RE: *Final*
Response to United States Environmental Protection Agency (EPA) E-Mail Comments
Dated April 10, 2008 on Interim Measures Work Plan (IMWP) for Solid Waste
Management Unit (SWMU) 13 (Mine Fill B)
Naval Surface Warfare Center (NSWC) Crane
Crane, Indiana

**RESPONSE TO NAVY COMMENTS DATED JUNE 9, 2008 (E-MAIL) ON
DRAFT APRIL 10, 2008 EPA COMMENT RESPONSES ON
INTERIM MEASURES WORK PLAN (IMWP)
FOR SWMU 13 – MINE FILL B
NAVAL SURFACE WARFARE CENTER
CRANE, INDIANA**

**RESPONSE TO COMMENTS (RTCs) DATED APRIL 10, 2008
FROM UNITED STATES ENVIRONMENTAL PROTECTION AGENCY (EPA)
(E-MAIL FROM PETER RAMANAUSKAS)
ON THE INTERIM MEASURES WORK PLAN (IMWP) RTCs DATED DECEMBER 20, 2007
FOR SWMU 13 – MINE FILL B
NAVAL SURFACE WARFARE CENTER
CRANE, INDIANA**

FIGURES 3-1, 3-2, AND 3-3

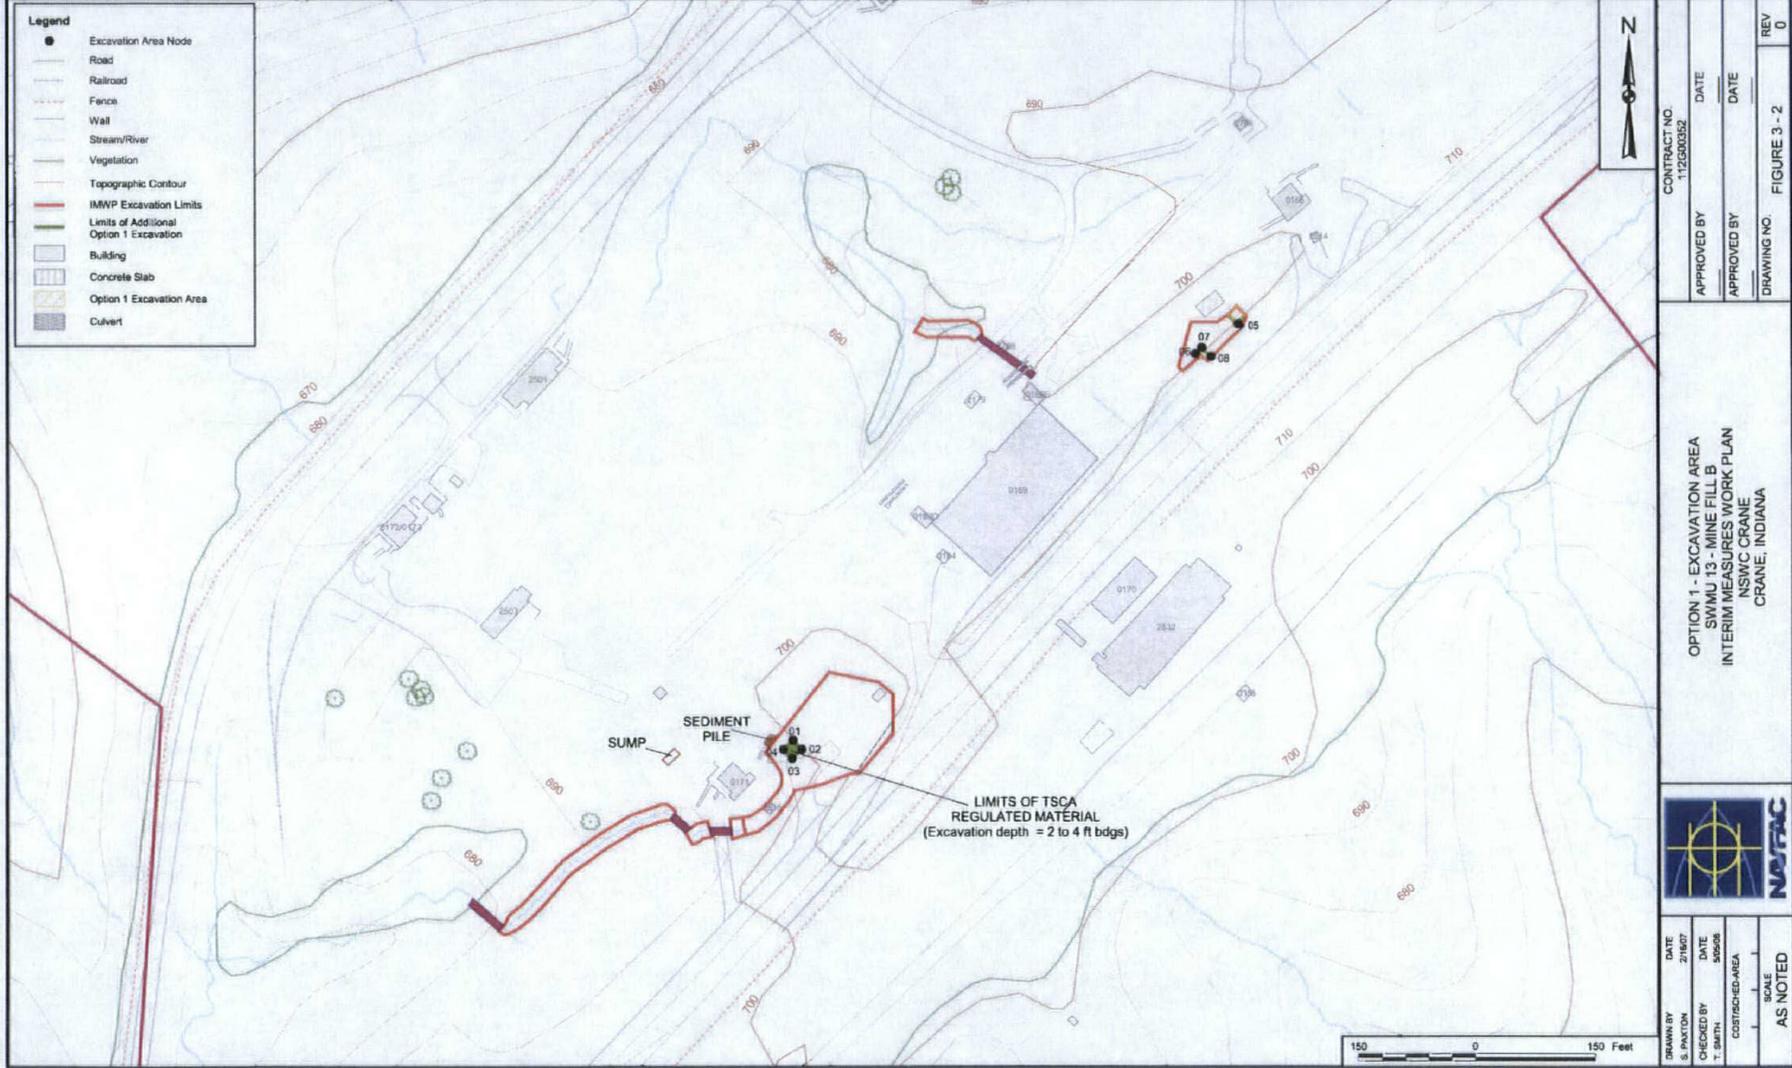
Response 1c does not address the comment. Overall, the text remains confusing with respect to which buildings were known to have PCB use and which buildings are having PCB contaminated soil removed. For example, Section 3 describes work around B-169 and B-171 but does not talk about B-166 while Figure 3-1 shows work proposed around B-166. Some places in the text discuss B-166/171 and others B-169/171. Please describe work taking place at all three buildings and what the sources of PCB were at each building. If a building did not have a source of PCB, describe how PCB came to be located near the building.

EPA-5c (4-10-08): Sediments must be tested for PCB concentration for disposal characterization prior to any consolidation. > 50 ppm and < 50 ppm materials should be kept segregated.

Response to EPA-1 (4-10-08): Figures 3-1, 3-2, and 3-3 indicate a fenced area northeast of Building 169 with "0166." This area is a fenced in area where the former Building 166 Therminol Boilers were located. The Therminol Boilers for Building 166 and Building 171 are believed to be the sources of polychlorinated biphenyl (PCB) contamination at SWMU 13 (Mind Fill B). PCB activities did not occur at Building 169. The purpose of referencing Building 169 is as a landmark for the remediation Environmental Multi Award Contractor (EMAC). The Navy believes that it is appropriate to use Building 169 as a landmark because of its location relative to the proposed remediation areas.

For clarification, Figures 3-1, 3-2, and 3-3 (See Attachment 1) have been modified to include a legend for the former foundation pad of the Therminol Boilers rather than fenced areas. Additionally, these figures have been modified to show Building 166.

Based on the available analytical data, 6 sample locations contain total-PCBs at concentrations that exceed 50 mg/kg. Figures 3-1, 3-2, and 3-3 have been revised to indicate the locations of the soils that must be stockpiled separately for disposal at a TSCA regulated landfill. Additionally, the text and volume tables have been updated to indicate the inclusion of material to be disposed at a TSCA regulated landfill. Additional sampling for disposal will be performed based upon requirements of the selected landfill.

FIGURE 3-4

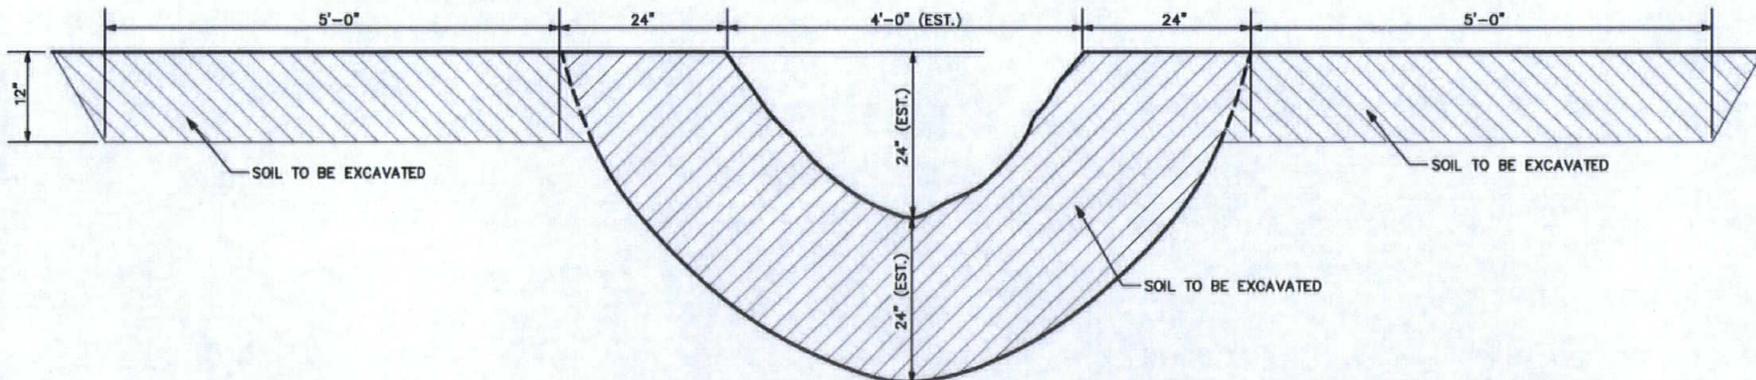
The Navy must take confirmation floor samples. The configuration of the drainage channel or excavation does not eliminate the requirement for confirmation sampling. Please propose a confirmation floor sampling plan.

Response to EPA-6(4-10-08): The excavation shape related to the drainage channel excavation is an irregular shape (see Figure 3-4 in Attachment 2). As a result of the irregular shape, verification samples will be collected from the exposed exaction floor of the channel overflow areas located on each side of the "V / U" shaped channel. Within the "V / U" shaped channel one verification sample will be collected from each of the exposed surface defining the sides of this "V / U" shaped excavation. To illustrate the locations of verification sample collection, a new figure (Figure 5-1 see Attachment 3) has been added to the text and is provide as part of this response to comment document.

- For the soil excavation areas, every 25 foot by 25 foot (e.g., 1 composite sample for every 625 square feet).
- For the channel excavation area of the drainage trenches, every 100 foot of excavation length. These excavations are approximately 6 foot by 100 foot (see Figure 3-4) (e.g., 1 composite sampler per 600 square foot).
- For the channel-overflow excavation area of the drainage trenches, every 100 foot of excavation length. These excavations are approximately 5 foot by 100 foot (see Figure 3-4) (e.g., 1 composite sampler per 500 square foot).

FIGURE 5-1

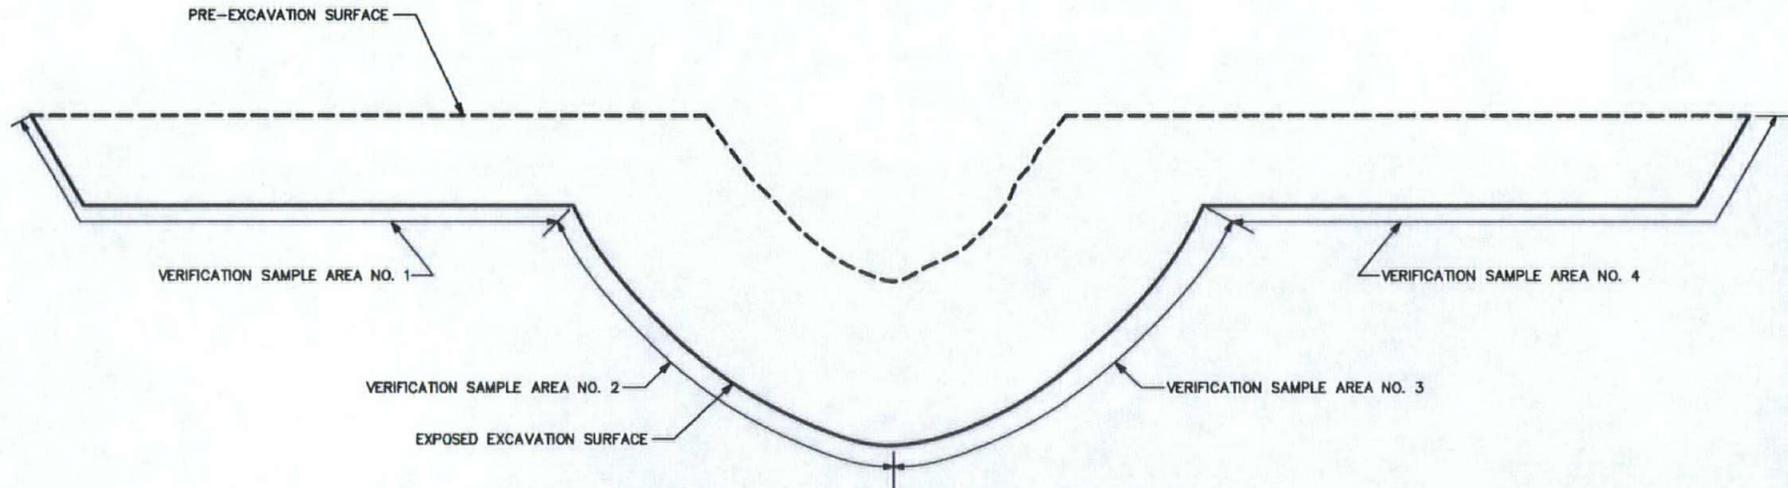
TB-3(6-9-08). In the italicized text at the bottom of p.4-5, change "form" to "from" in the 2nd sentence ("Due to . . . (Figure 5-1)").

"... Due to the irregular shape of the drainage channel excavation (see Figure 3-4), two verification samples will be collected from the exposed overflow floor areas located on each side of the channel (i.e., from the channel overflow areas) and two verification samples will be collected from the exposed surfaces of the drainage channel (Figure 5-1)."

- *"Drainage Channel Excavation Areas - Verification samples will be collected from the excavation sidewalls and floors. Due to the irregular shape of the drainage channel excavation (see Figure 3-4), two verification samples will be collected from the exposed overflow floor areas located on each side of the channel (i.e., from the channel overflow areas) and two verification samples will be collected from the exposed surfaces of the drainage channel (Figure 5-1). Verification samples will be composite samples as described in the QAPP (TtNUS, 2006). These four composite samples make up one set of verification samples. At a minimum, one set of verification samples will be collected from each drainage channel segment and for every 100 linear feet of drainage channel excavation. In the event that a drainage pipe is encountered during the drainage channel excavation process, the frequency of verification sample collection will be increased to one set of verification samples for every 25 linear feet of drainage channel excavation. Therefore, based on the proposed length of drainage channel excavation within 100 feet downstream of the piping outlet areas, if drainage pipes are not encountered, seven sets*
